UL upgrade from UL 498 to UL 60320-1.
Marking for UL rating 7A/125V~ updated.

Product Change Notification					2565 Change of marking		
owner	creation date	release date	released by	change order no	rev	page	
zeierjo	31.03.2021	31.03.2021	muehlema	2020050	C	1 of 1	D10-052-457

3 Detailed description of change

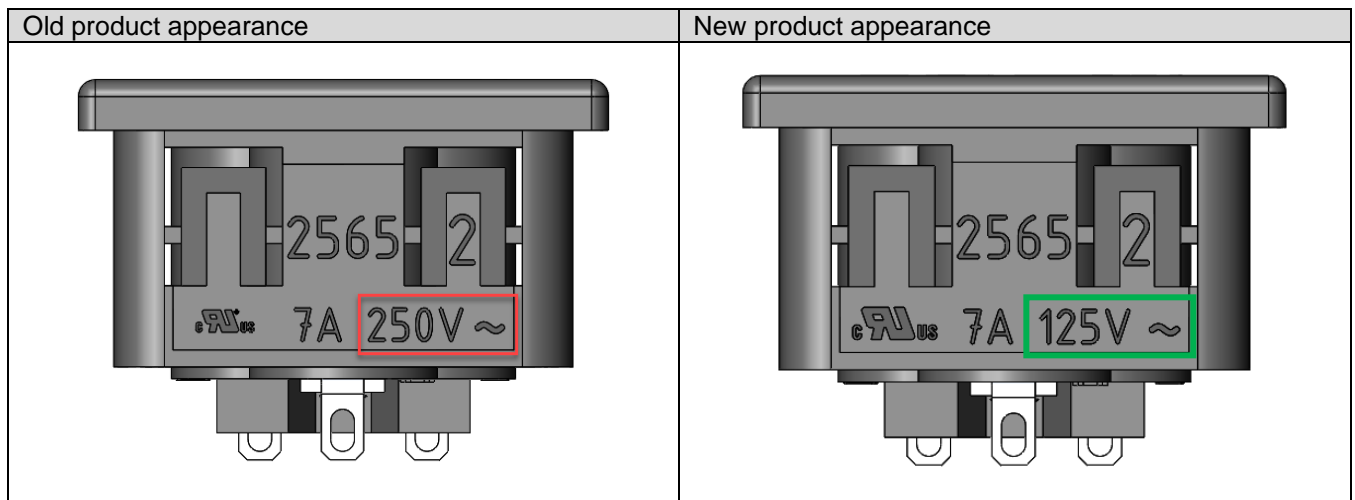
Form	Yes	Change of rating marking.
Fit	No	-
Function	No	-
Manufacturing	No	-
Label	No	-
Packaging	No	-
